UNITED STATES
DEPARTMENT OF THE INTERIOR
BUREAU OF LAND MANAGEMENT

SUNDRY NOTICES AND REPORTS ON WELLS
*Do not use this form for proposals to drill or to re-enter an
abandoned well. Use Form 3160-3 (APD) for such proposals.*

1 Type of Well ☒ Oil Well ☐ Gas Well ☐ Other		5 Lease Serial No NMNM96848
2 Name of Operator Marbob Energy Corporation		6 If Indian, Allottee, or Tribe Name
3a Address PO Box 227 Artesia, NM 88211-0227	3b Phone No. (include area code) (575) 748-3303	7 If Unit or CA Agreement Name and/or No
4 Location of Well (Footage, Sec., T., R., M. or Survey Description) 660 FNL 660 FWL, Sec. 21-T25S-R29E, Unit D		8 Well Name and No Save DA 21 Federal #1
		9 API Well No 30-015-34840
		10 Field and Pool, or Exploratory Area Willow Lake; Bone Spring, SE
		11 County or Parish, State Eddy Co., NM

Marbob Energy Corporation proposes to add pay in the Bone Spring zone as follows:

Well: SAVE DA 21 Fed. 1

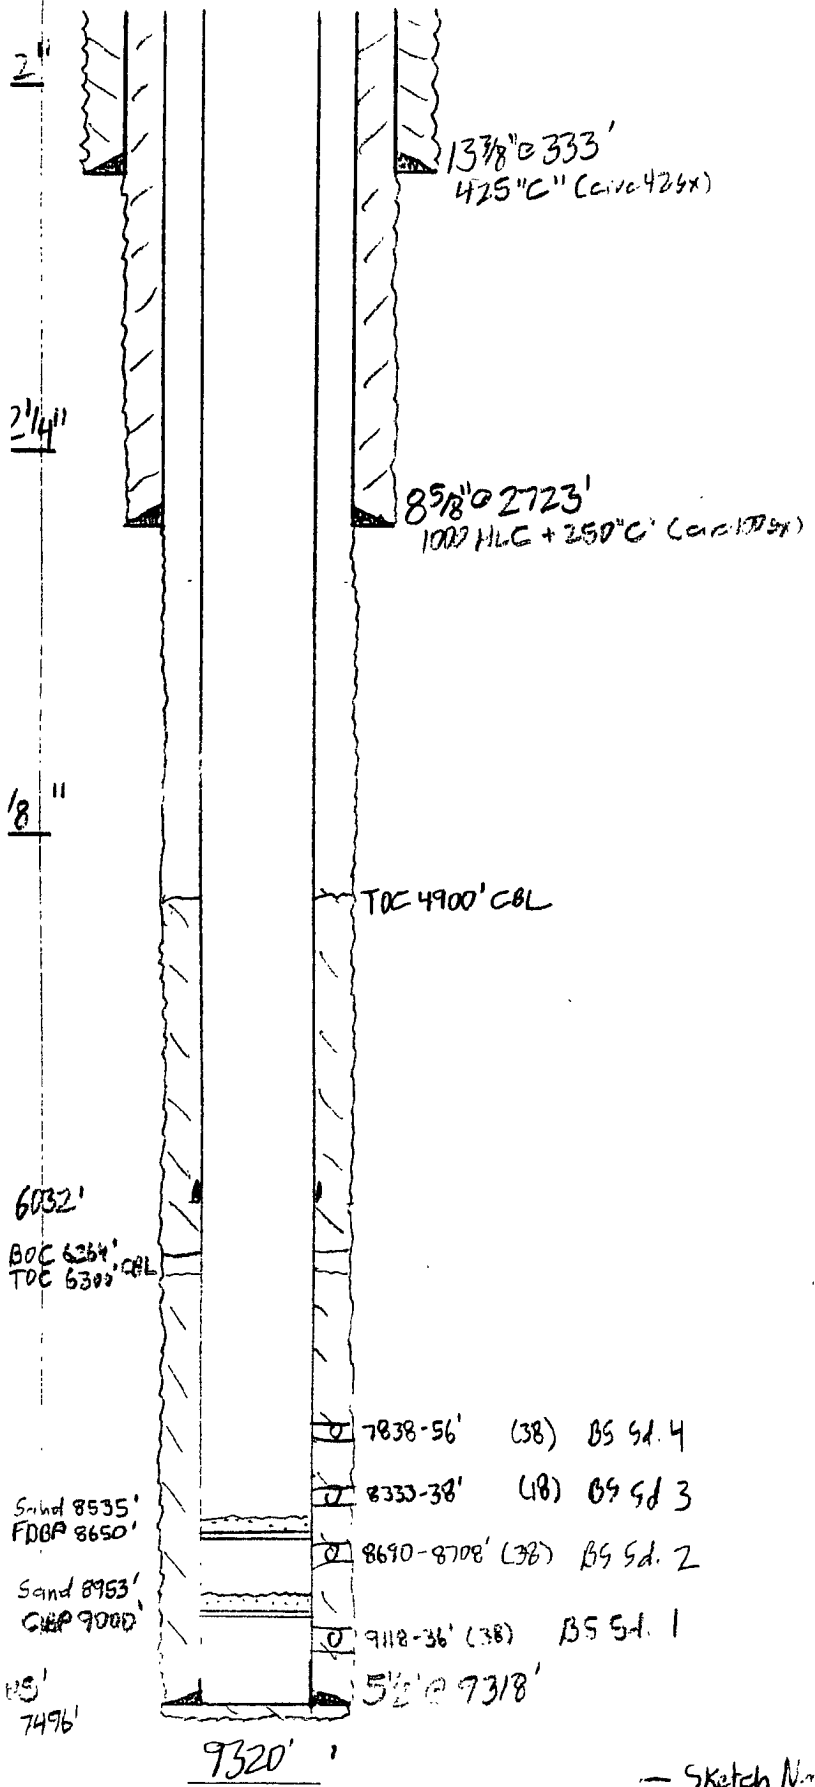
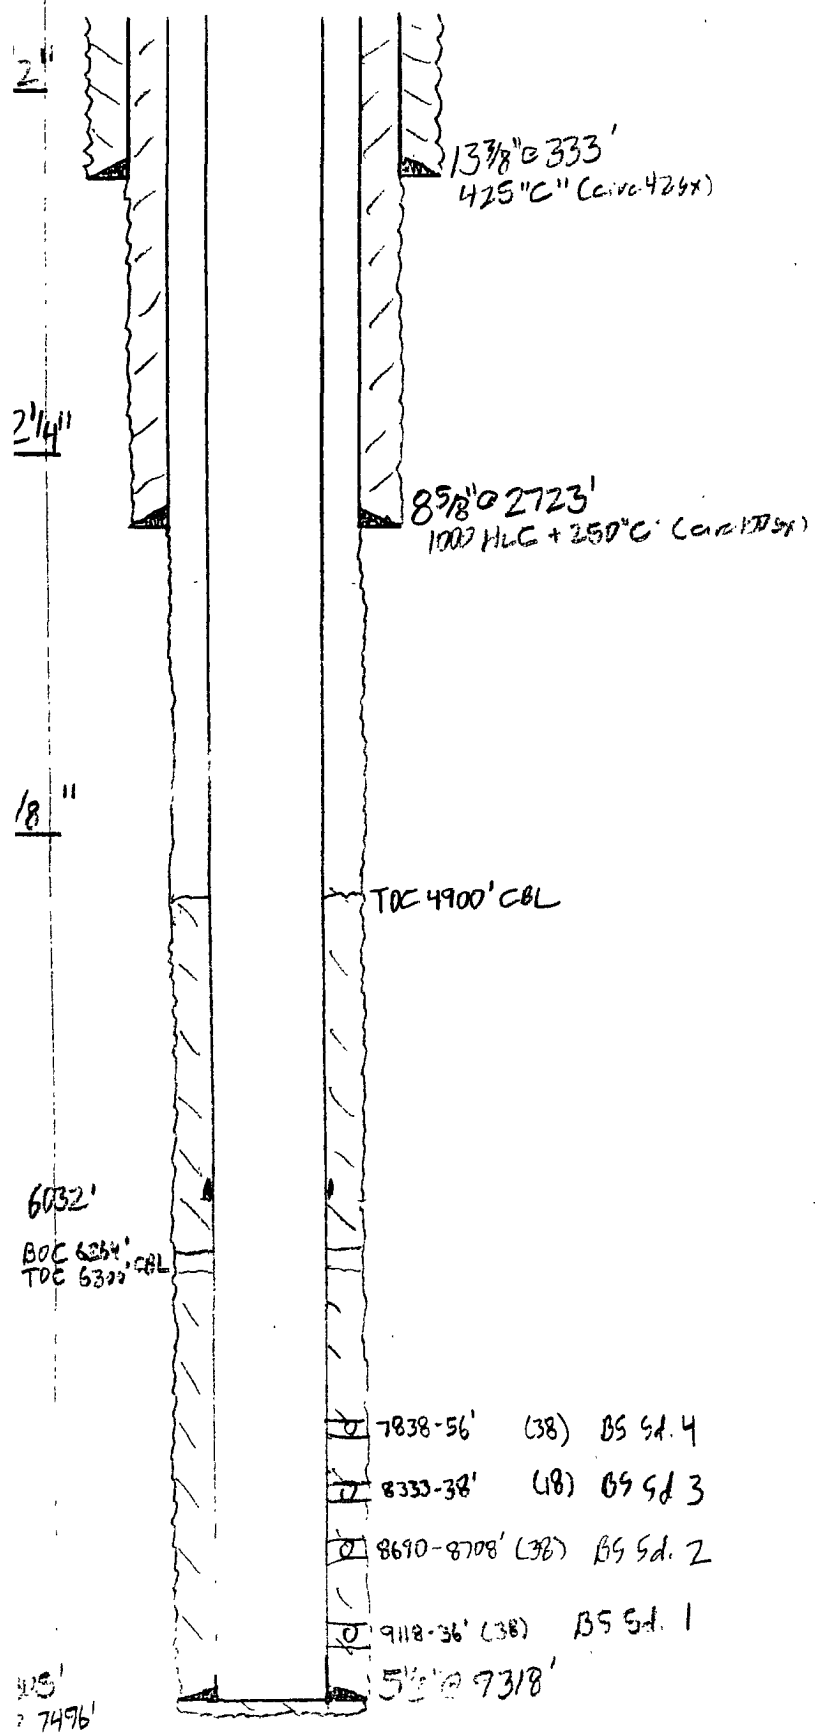
1. Drill out sand fill & plugs @ 8650' & 9000' to put all Bone Spring sands together. Clean out to 9200' if possible
2. PWOP w/ S/N @ appx 9190' & TAC @ appx 7700'.

(See wellbore schematics attached)
